STATE OF WASHINGTON
DEPARTMENT OF ECOLOGY

March 10, 2006

Re: Ecology Response Letter: Evaluation for the Potential for Subsurface Vapor Intrusion, Former GE South Dawson Street-Facility, Seattle, Washington-dated February 6, 2006

FIGURE 5-1

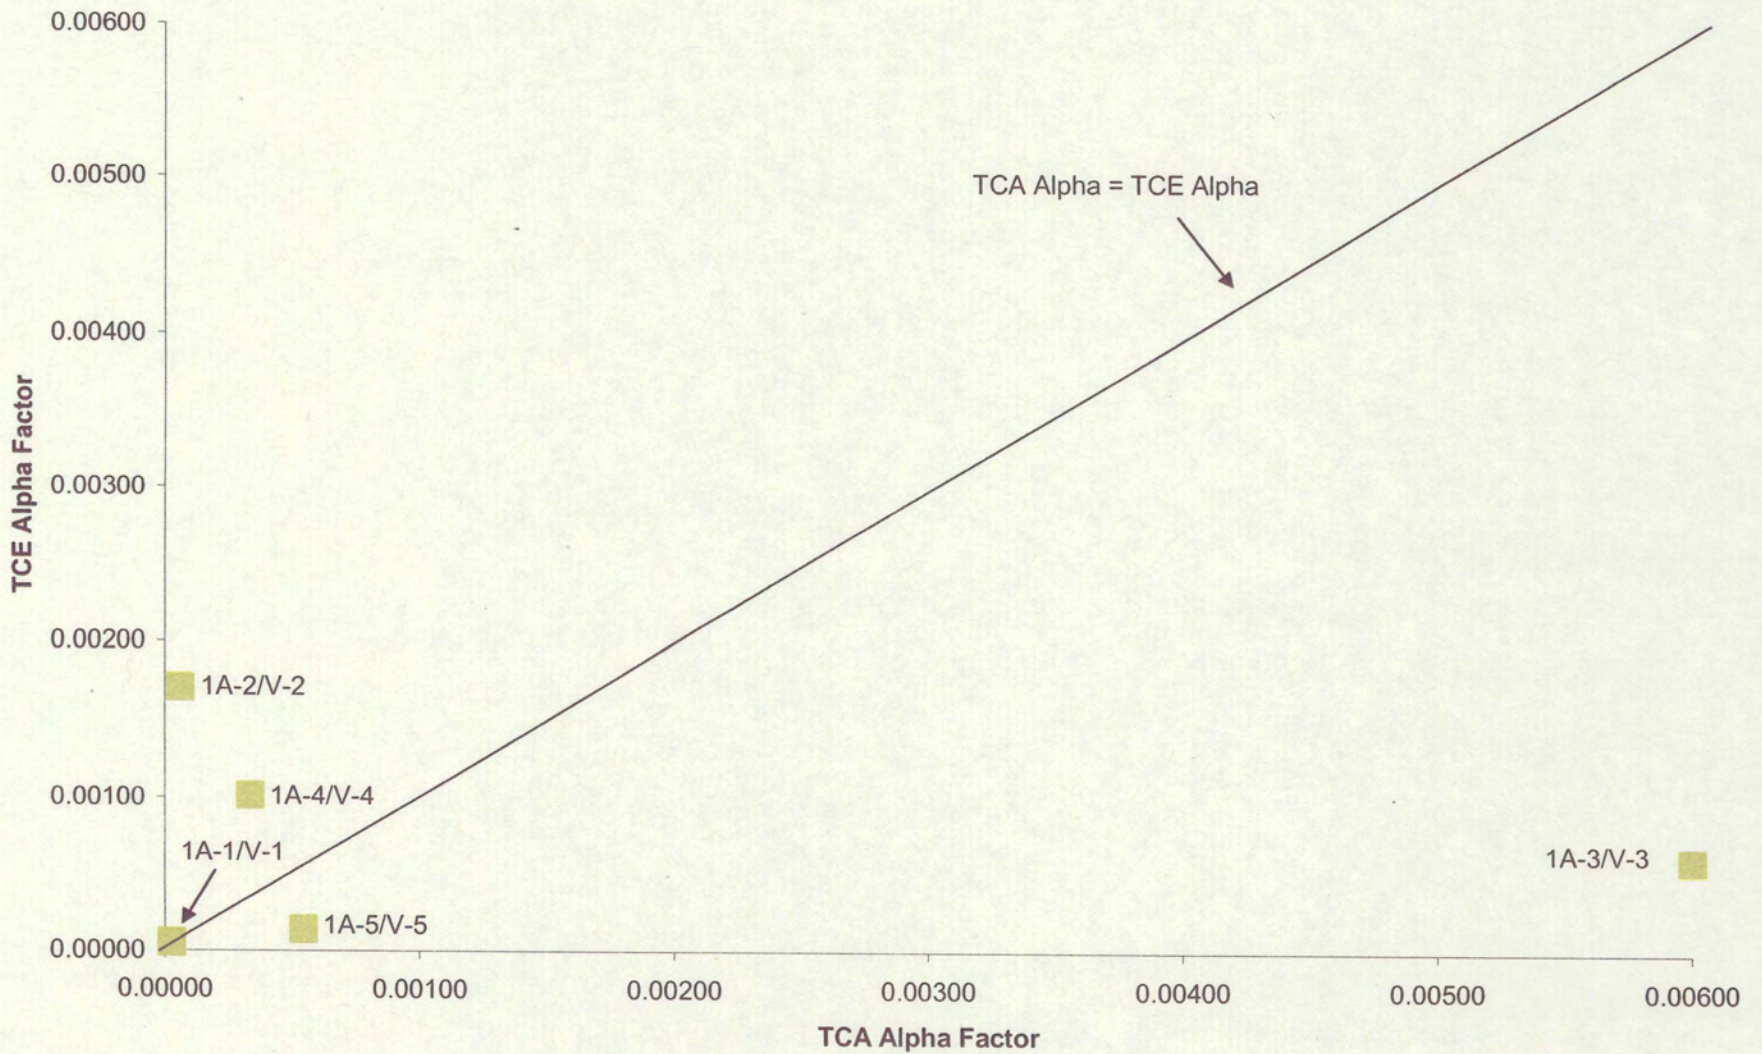
Ecology interprets Figure 5-1 as showing that the Sample Area-specific attenuation factors and measured sub-slab vapor TCE and ICA concentrations both have an influence on each Sample Area indoor air TCE and ICA concentration.
